# BRADLEY HEIGHTS APARTMENTS

## Stormwater Site Plan

### Preliminary Drainage Report

Use correct address. [Storm Report; Pg 3 of 92]

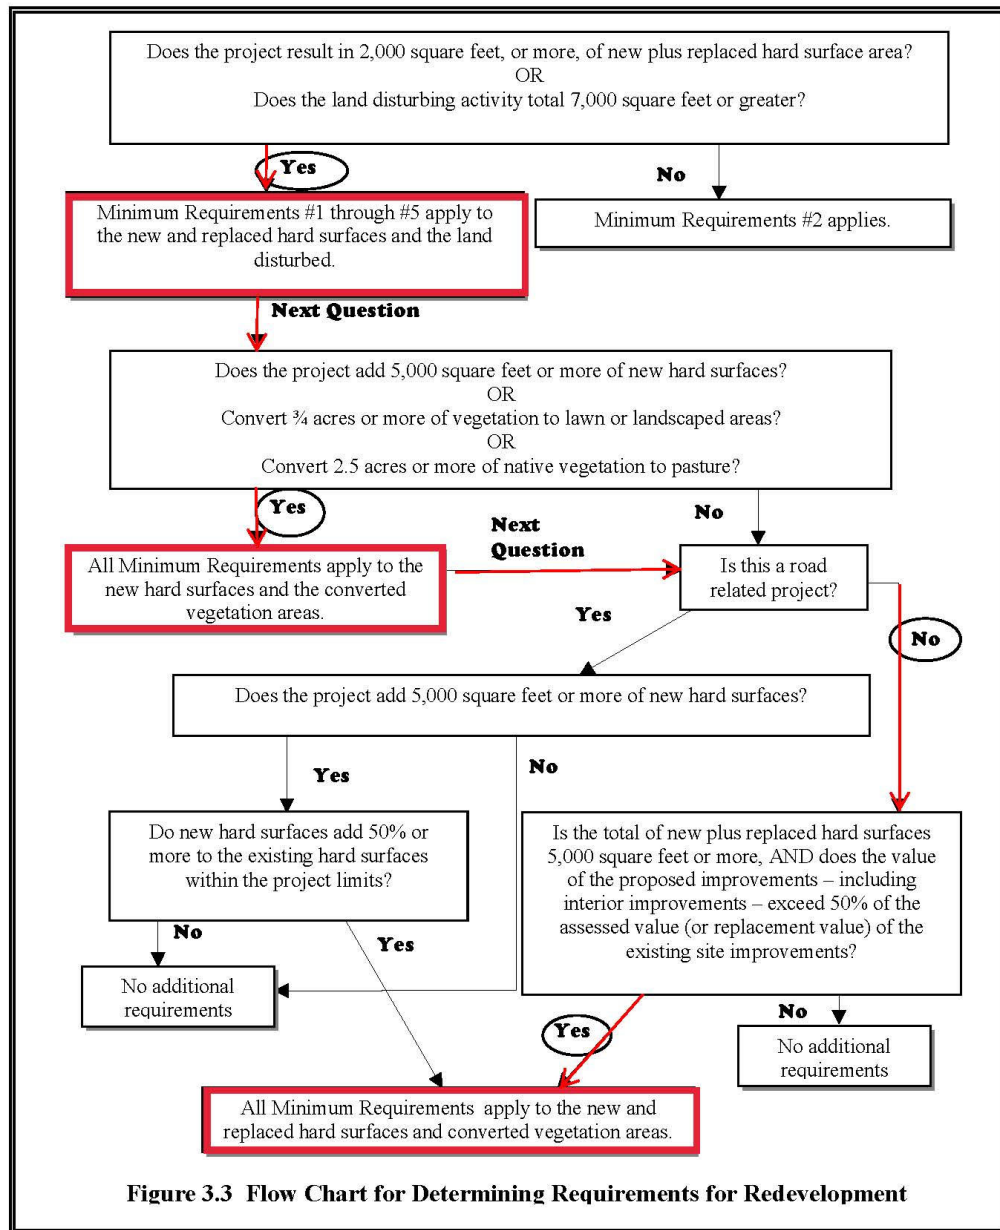
South side. [Storm Report; Pg 3 of 92]

The City will adopt the 2019 Ecology Manual as of July 1, 2022. Since Preliminary Site Plan applications are not a vesting tool, the stormwater design shall adhere to the 2019 Ecology Manual. [Storm Report; Pg 3 of 92]

**Site and Exploration Plan**

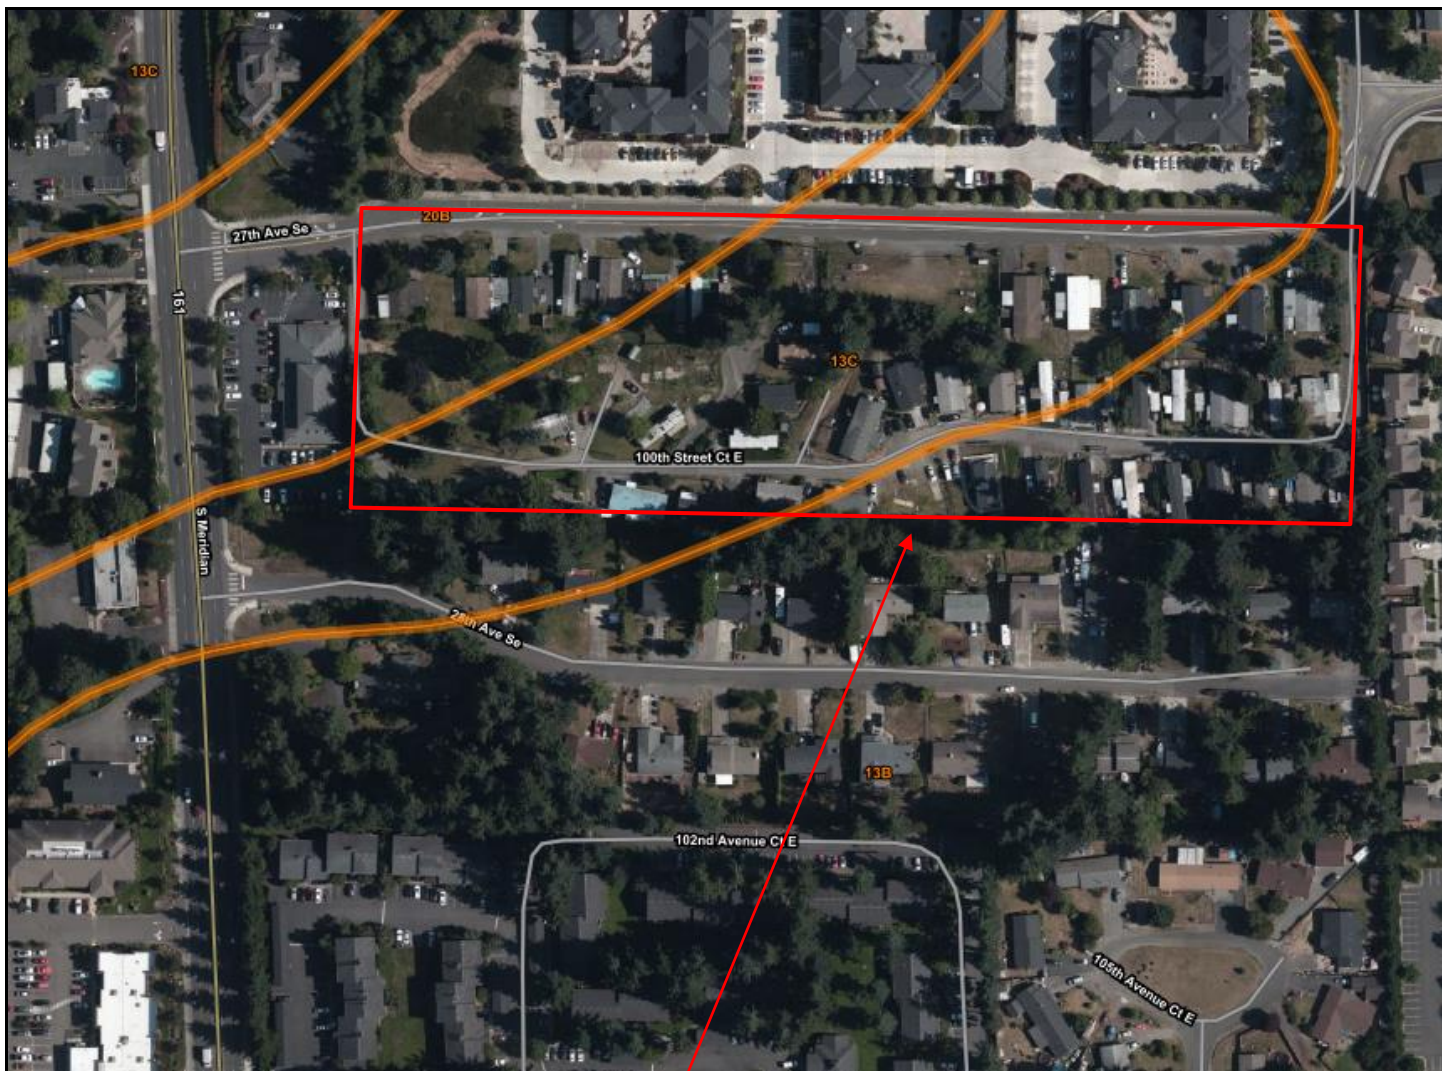
Location of PIT Test. Clarify why the infiltration testing was accomplished only in the Type C material vs the much larger Type A/B soils. At the time of civil application, additional infiltration testing or additional clarification from the geotechnical engineer is needed to justify a determination of BMP infeasibility for the central and eastern portions of the project site. [Storm Report; Pg 75 of 92]
